Subject: Oyster Creek Nuclear Generating Station
Facility License No. DPR-16
Docket No. 50-219
Response to Request for Additional Information re:
Proposed License Amendment for Spent Fuel Pool Expansion

Enclosure 1

Attachment 1.5

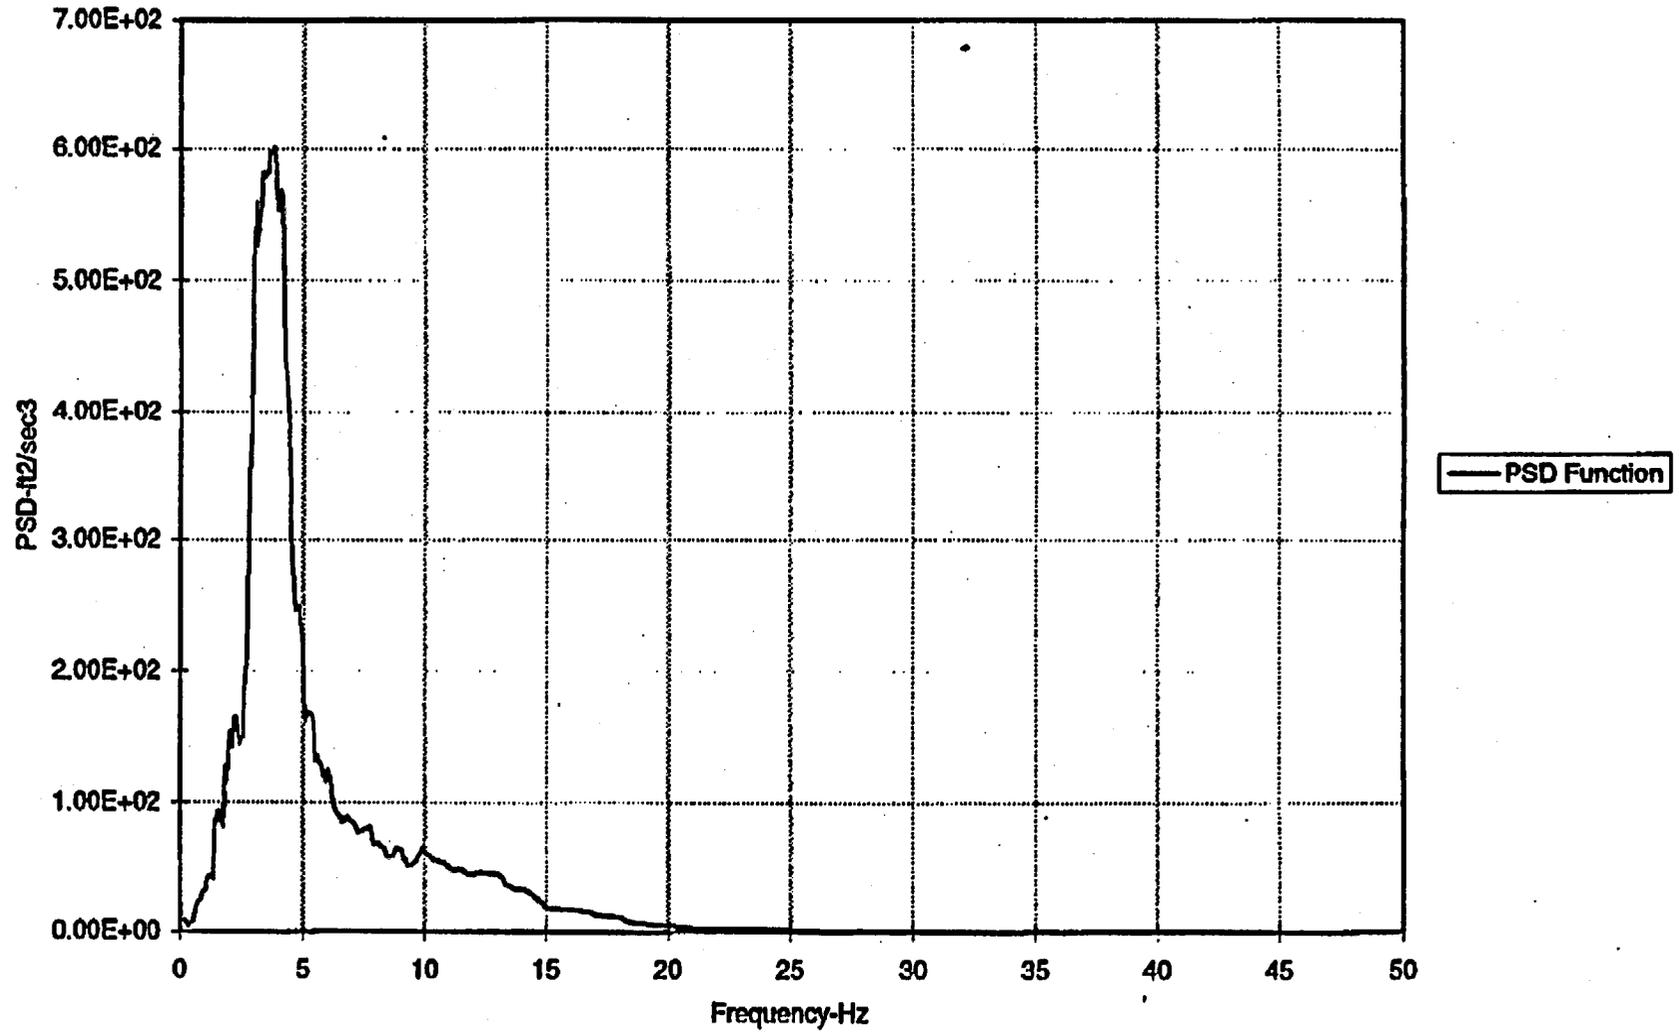
- (c) Provide the physical dimensions of the racks, and the gaps between the racks and the gaps between the racks and the spent fuel pool (SFP) walls.
- (d) Demonstrate that the artificial seismic ground motion time histories used in the analyses satisfy the power spectral density (PSD) requirement of SRP 3.7.1.

The SSE time histories for use in the DYNARACK analyses were also developed by EQE. Attachment 1.4 presents Section 7.0 and Figures 7-1 through 7-6 from the EQE calculation which demonstrate that the time histories derived contain the correct energy distribution with respect to frequency. The OBE time histories, which were generated by Holtec International, also meet the PSD requirements of SRP 3.7.1. Attachment 1.5 contains figures, which provide a comparison of the PSD curves associated with the generated time histories and the PSD curves associated with the design basis response spectra. These figures clearly show that the generated PSD curves envelop the target curves over the entire frequency range.

The "raw" and smooth power spectral density functions are shown in Figures 7-1 to 7-6. There, it is shown that the generated horizontal time histories have the energy concentrated in the 3 to 4 Hz range and practically no energy after 8 to 10 Hz. The vertical time history has a large amount of energy in the 3 to 4 Hz range but also has energy between 4 and 20 Hz. This is consistent with the target floor response spectra and with the characteristics of the dynamic response of the reactor building.

Isometric View of the Finite Element Mesh

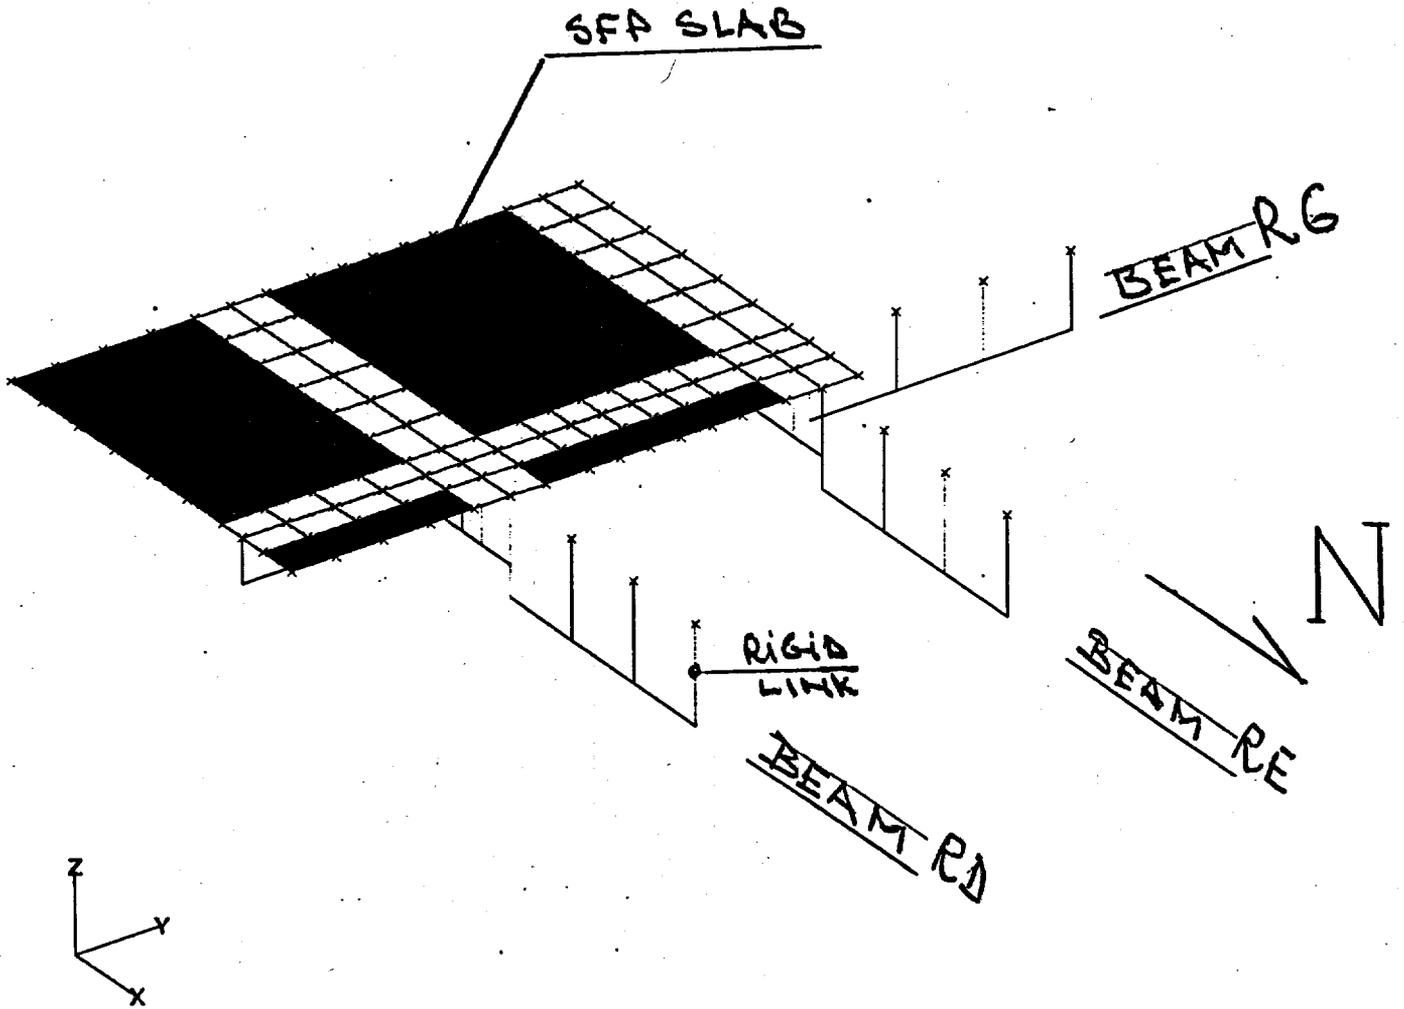
- (a) Provide the physical dimensions of the reinforced concrete slab and walls, liner plate and the details of liner anchorage; also provide the material properties used in the analysis.
- (b) Provide the mesh used in the analysis; describe the boundary conditions and indicate them in the mesh.
- (c) Describe the applied loading conditions including magnitudes, and indicate their locations in the mesh.
- (d) Explain how the interface between the liner and concrete slab is modeled, and also, how the liner anchors are modeled; explain how such modeling accurately represents the real structural behavior.
- (e) Provide the calculated governing factors of safety in a tabular form for the axial, shear, bending and combined stress conditions in the spent fuel pool.

The finite element model encompasses the entire area of interest, i.e., the reinforced concrete slab, its three supporting beams, and the SFP walls. Attachment 2.1 provides an isometric view of the mesh. The interaction of the spent fuel pool with the rest of the Reactor Building is simulated by appropriate boundary conditions. Attachment 2.2 indicates the type and locations of the boundary conditions.

[†] Attachment 2.1 shows the locations of the structural elements.
